ADDENDUM #3

September 25, 2017

**UNC Charlotte Sycamore Hall Renovation
Charlotte, North Carolina
SCO #16-12735**

1 CONSTRUCTION PHASING PLAN - SITE
1" = 20'-0"

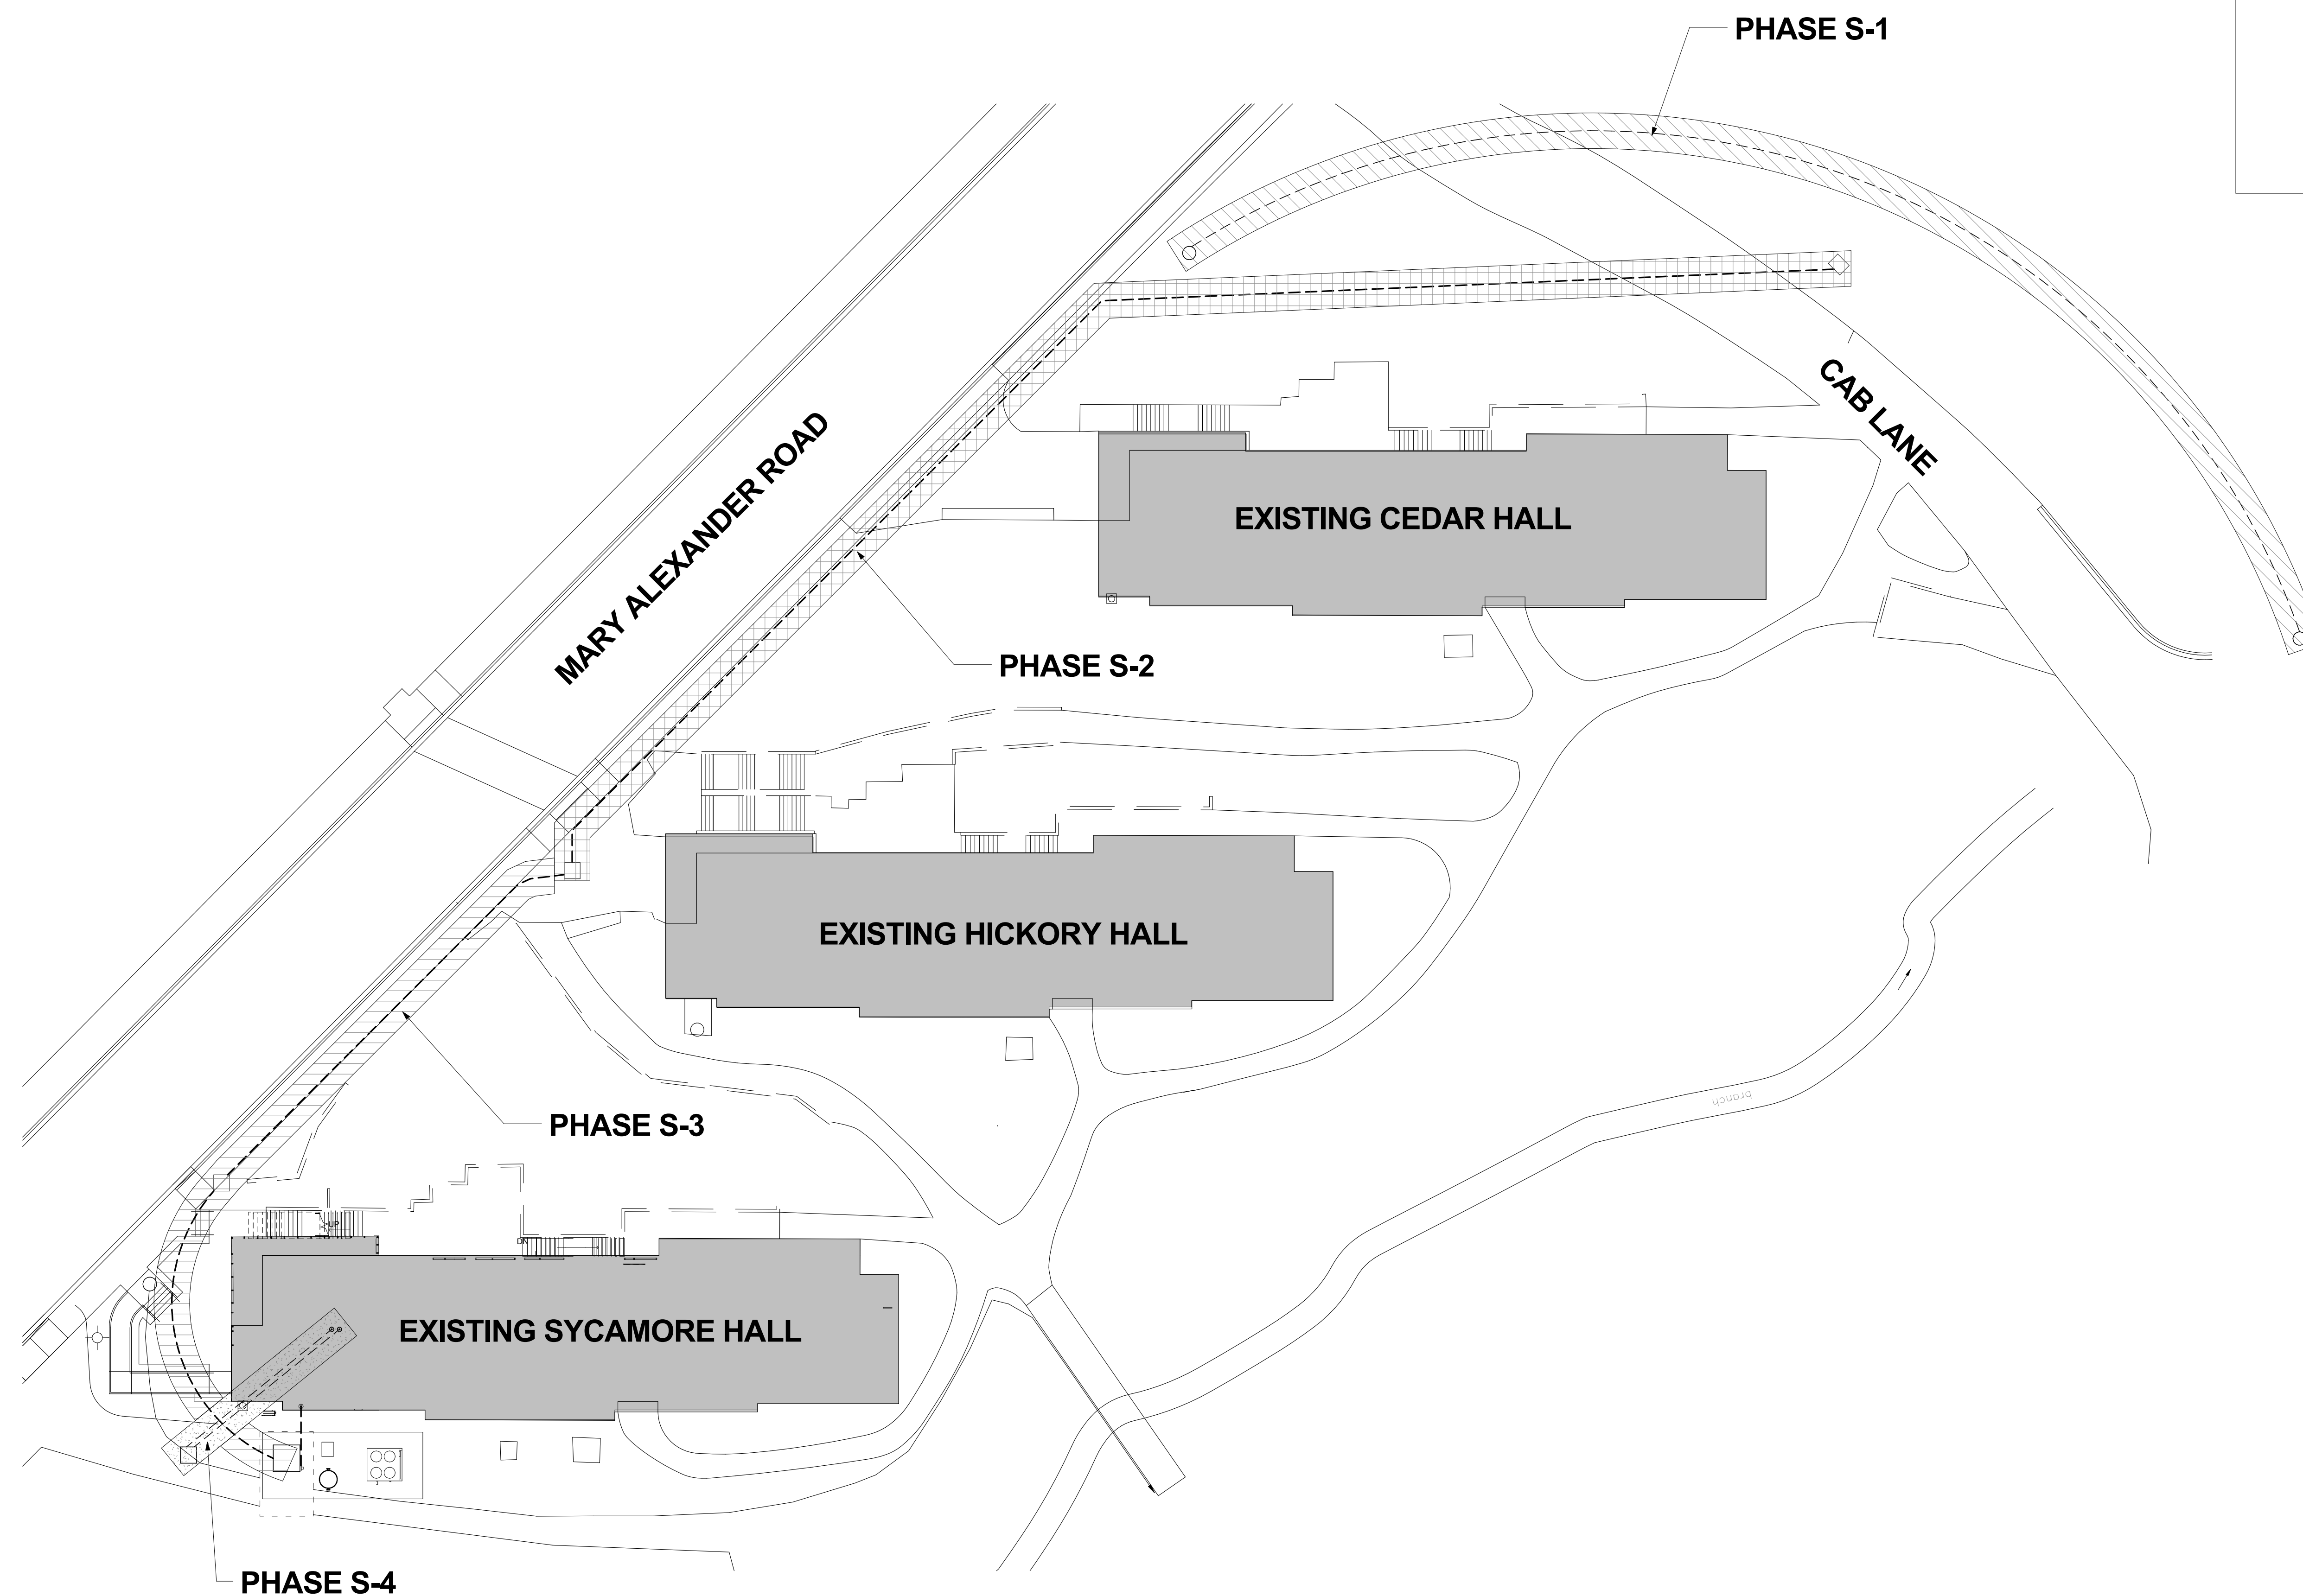
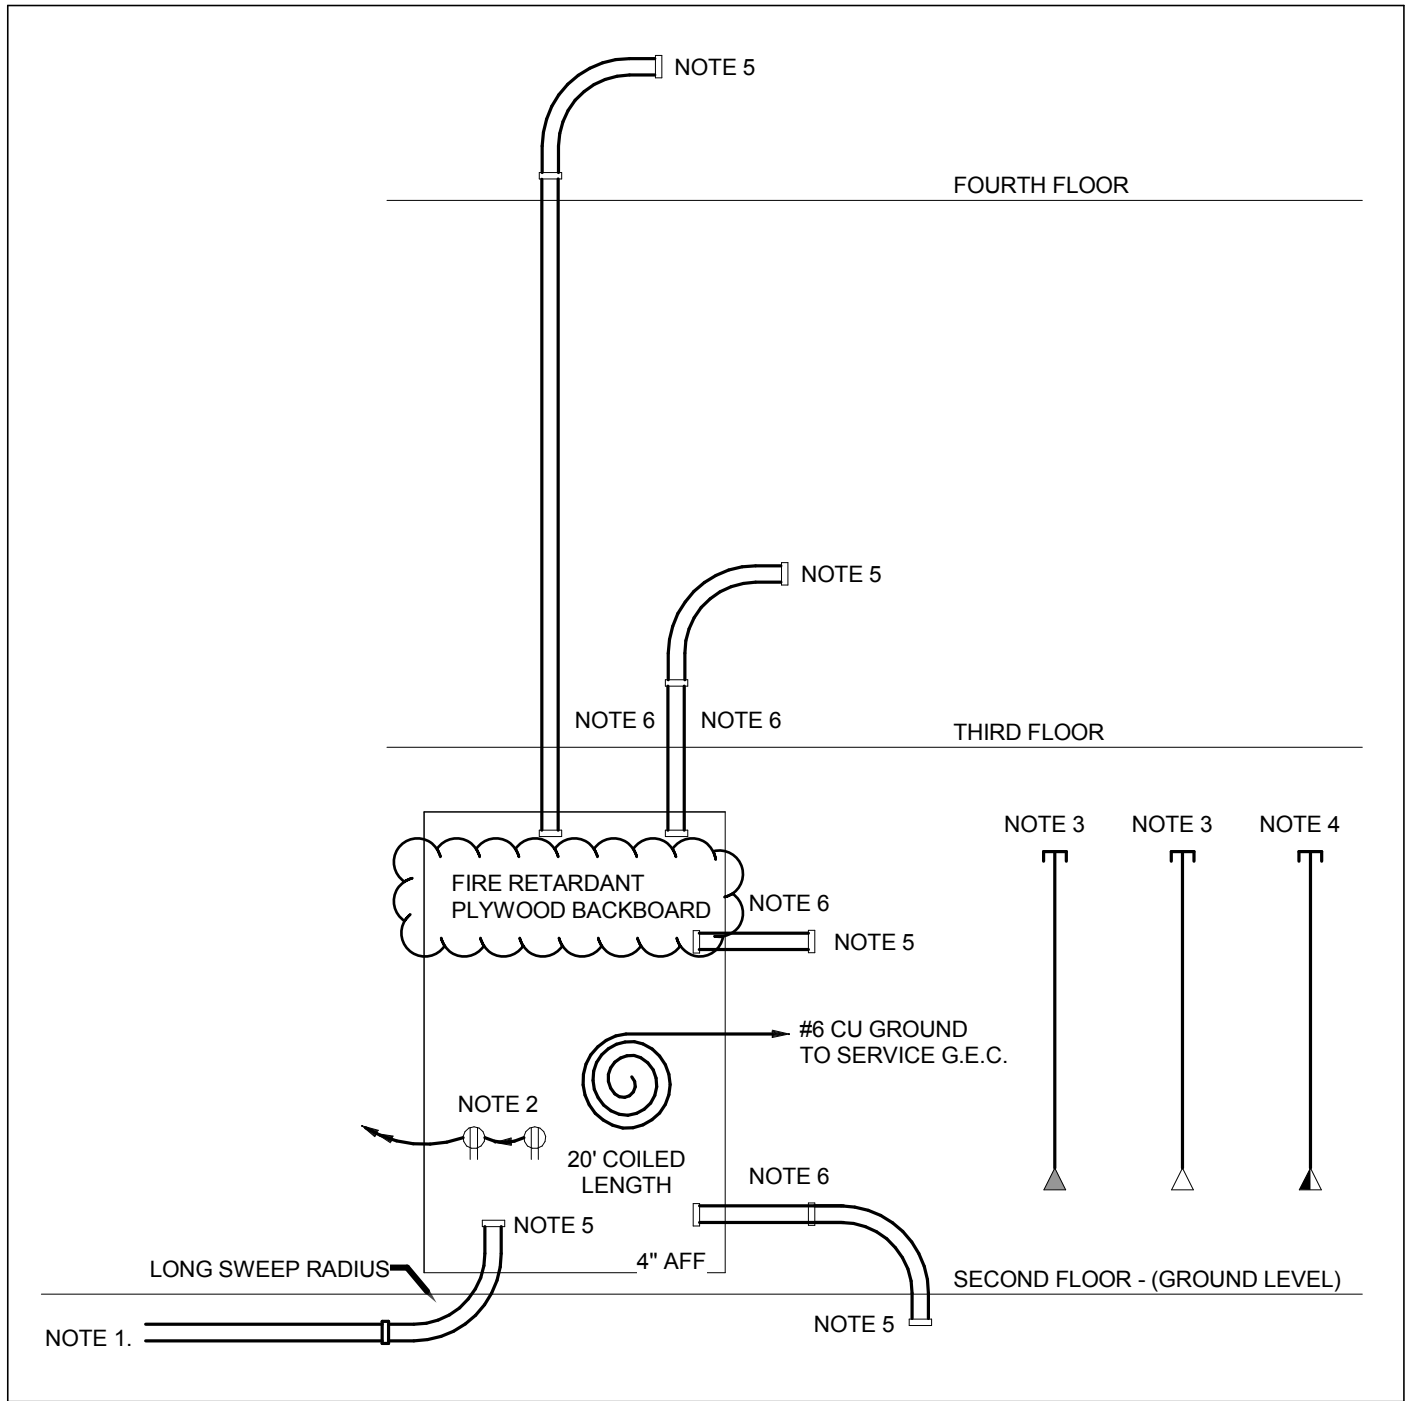
PHASE "S-1"
1. START: NOTICE TO PROCEED
2. COMPLETE: PRIOR TO PHASE "S-4"
3. INCLUDES BUT NOT LIMITED TO:
• NEW TELECOM DUCTBANK WITH (1) 4" DIRECT-BURY CONDUIT FROM MANHOLE 58-A TO MANHOLE 58.

PHASE "S-2"
1. START: NOTICE TO PROCEED
2. COMPLETE: PRIOR TO PHASE "S-3"
3. INCLUDES BUT NOT LIMITED TO:
• PROVIDE NEW TAP ON EXISTING 3-PHASE SERVICE LINE TO CEDAR HALL BUILDING.
• NEW TAP SHALL RUN IN EXISTING SPARE CONDUIT BETWEEN SWITCH 64 AND MANHOLE 65.
• SEE SHEET E002 AND E003.

PHASE "S-3"
1. START: FOLLOWING COMPLETION OF PHASE "S-2"
2. COMPLETE: PRIOR TO PERMANENT POWER FOR SYCAMORE
3. INCLUDES BUT NOT LIMITED TO:
• NEW ELECTRICAL DUCTBANK FROM MANHOLE 65 TO NEW TRANSFORMER.
• NEW MANHOLE AS INDICATED ON SHEET E002 AND E003.

PHASE "S-4"
1. START: FOLLOWING COMPLETION OF PHASE "S-1"
2. COMPLETE: PROJECT COMPLETION DATE
3. INCLUDES BUT NOT LIMITED TO:
• PROVIDE NEW QUARTZITE BOX TO INTERCEPT EXISTING DIRECT-BURIED TELECOM CABLES AS INDICATED ON E002.
• PROVIDE (2) 4" CONDUITS FROM NEW QUARTZITE BOX TO TELECOM ROOM 201.
